CITY OF ALBUQUERQUE

**Re: Lot 5 Block 3 Volcano Cliffs SAD 228
6320 Camino Alto
Request Permanent C.O. – Not Accepted
Engineer's Stamp dated: 1-31-17 (D10D003R5)
Certification dated: None**

Based on the Certification received 7/26/2017, the site cannot be accepted for release of Certificate of Occupancy by Hydrology until the following comment is addressed.

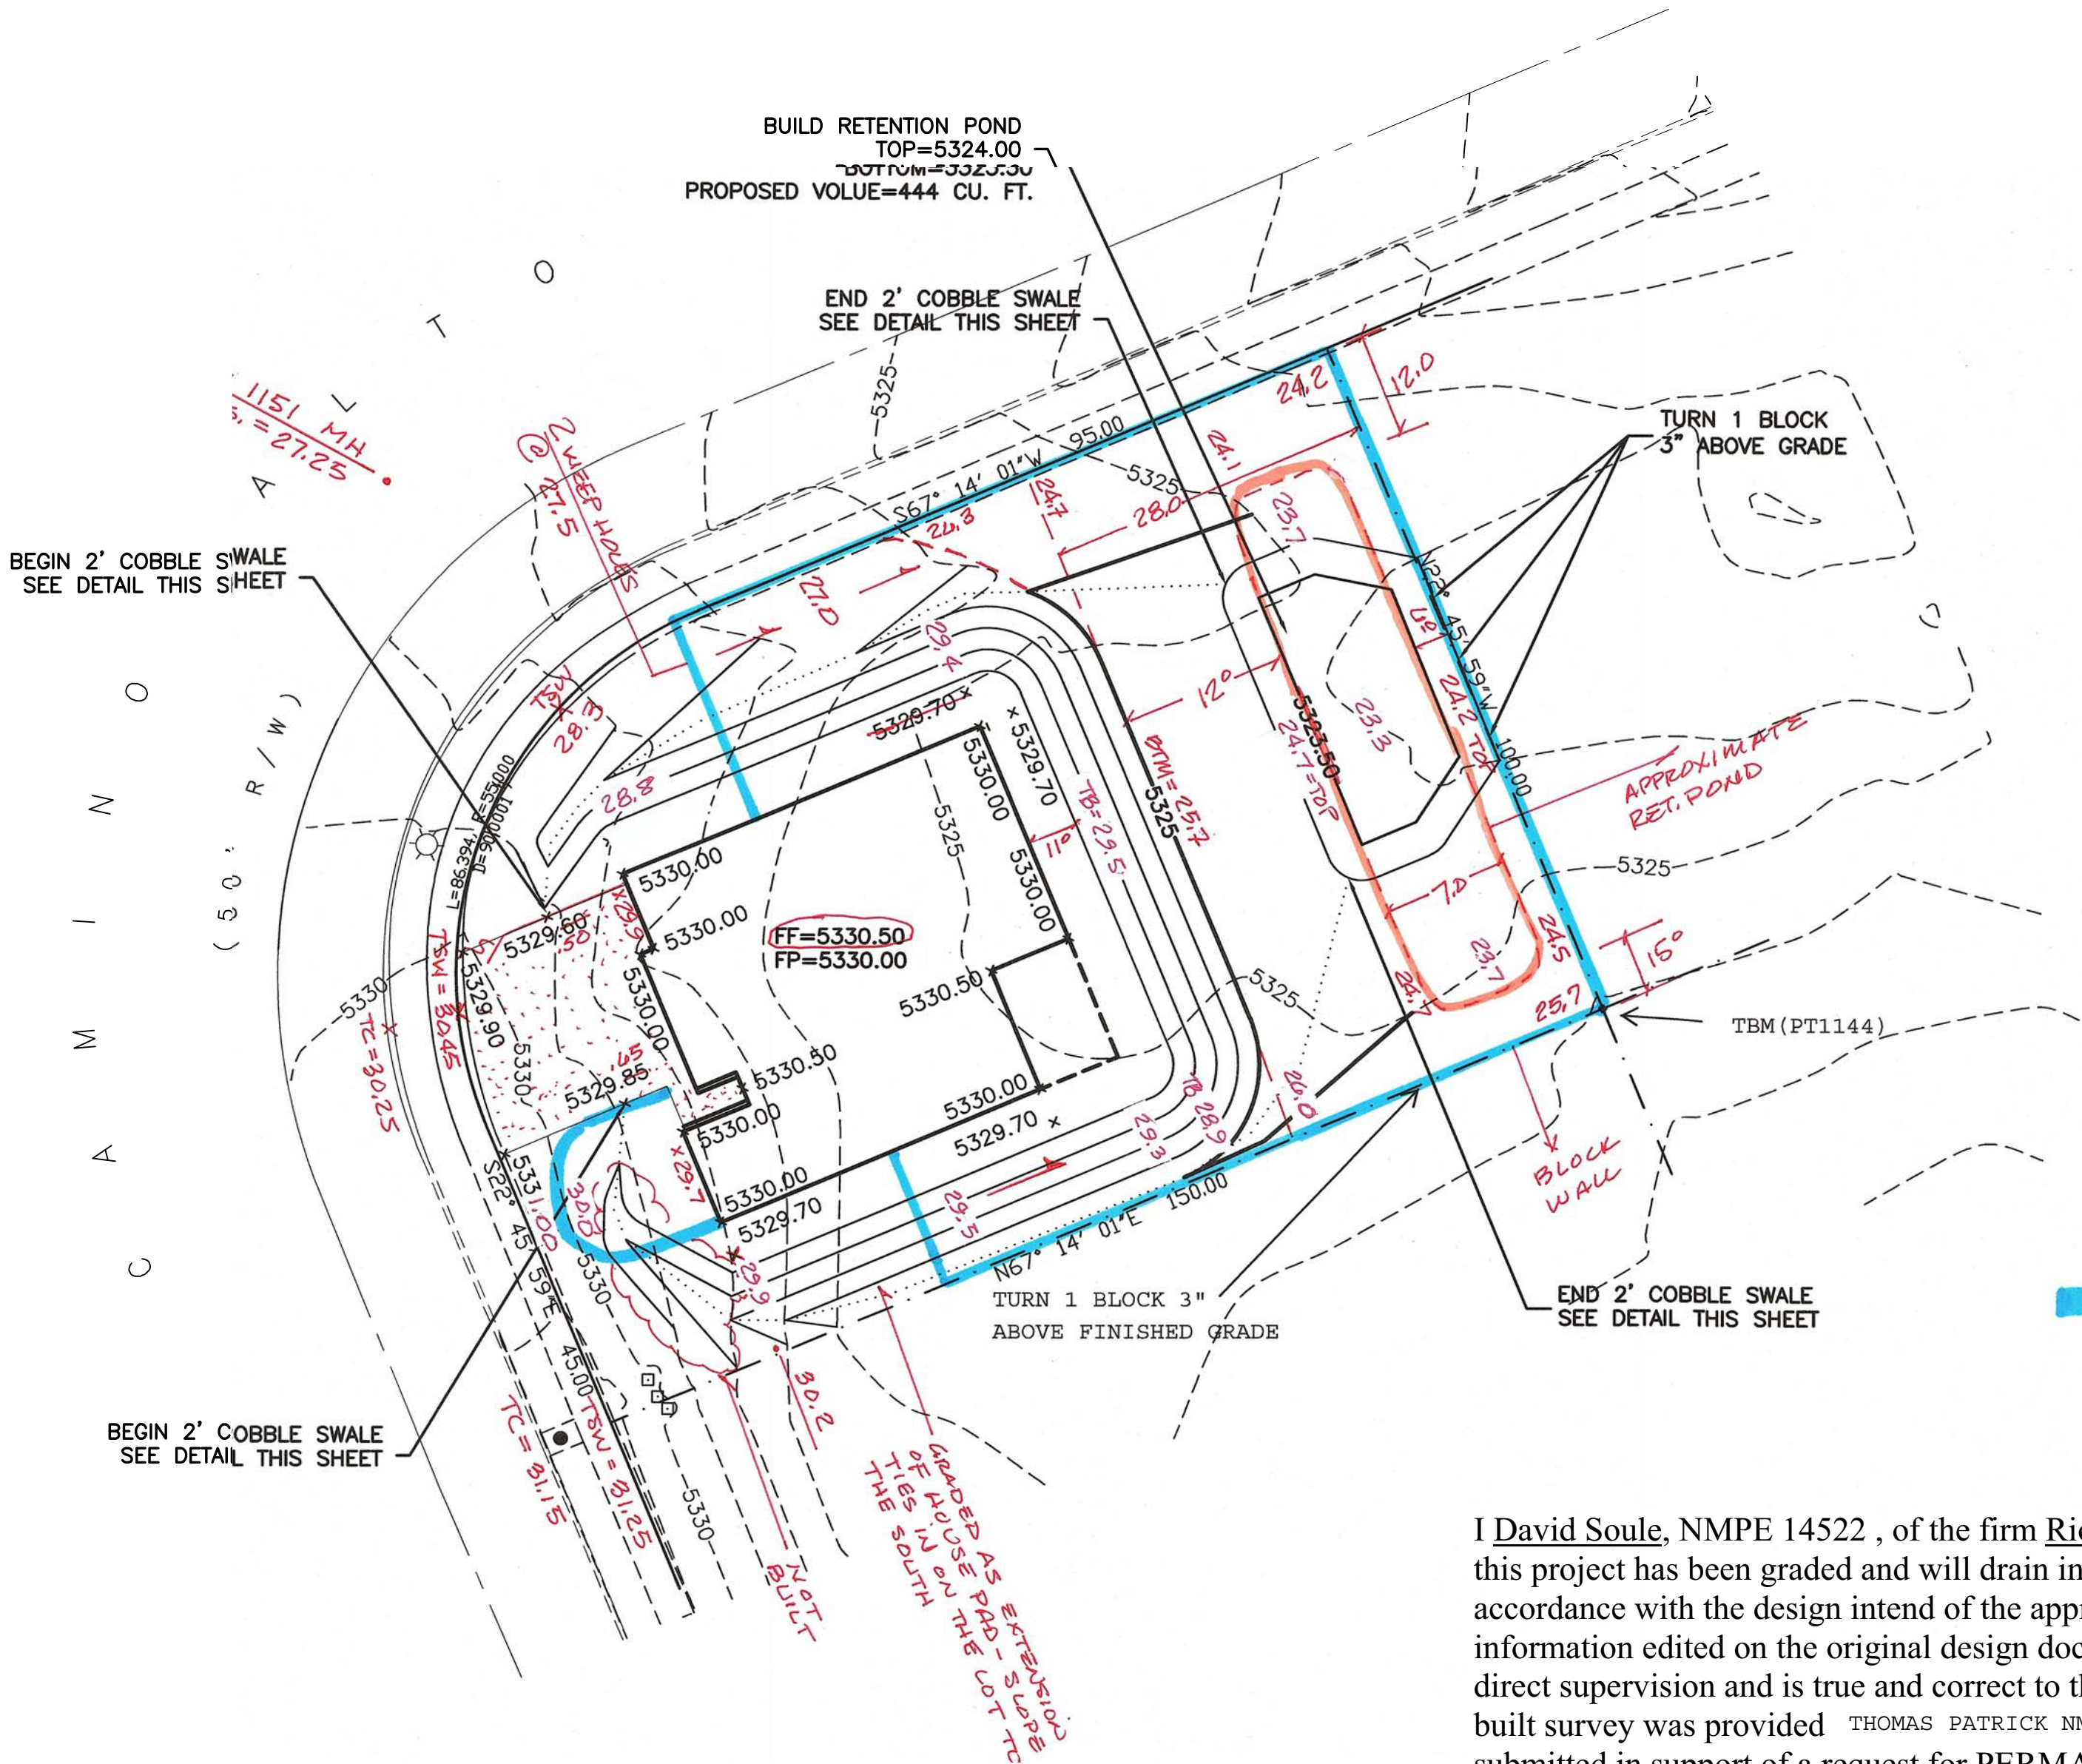
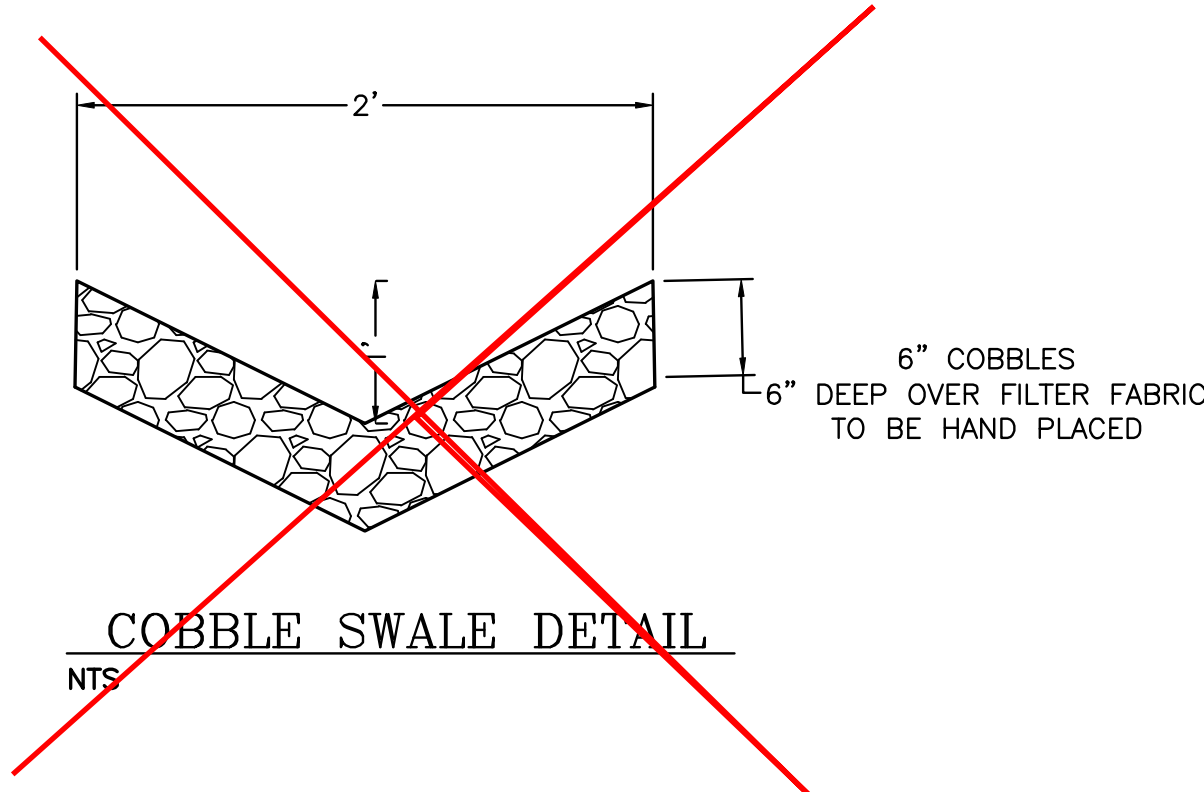
- Provide the language for the Certificate of Occupancy with your signature and date on the plan dated 1/31/17.

I David Soule, NMPE 14522, of the firm Rio Grande Engineering, hereby certify that this project has been graded and will drain in substantial compliance with and in accordance with the design intend of the approved plan dated 12/27/16. The record information edited on the original design document has performed by me or under my direct supervision and is true and correct to the best of my knowledge and belief. The as-built survey was provided THOMAS PATRICK NMPLS #12651. The certification is submitted in support of a request for PERMANENT CERTIFICATE OF OCCUPANCY. The record information presented heron is not necessarily complete and intended only to verify substantial compliance of the grading and drainage aspects of this project. Those relying on this record document are advised to obtain independent verification of its accuracy before using it for any other purpose.
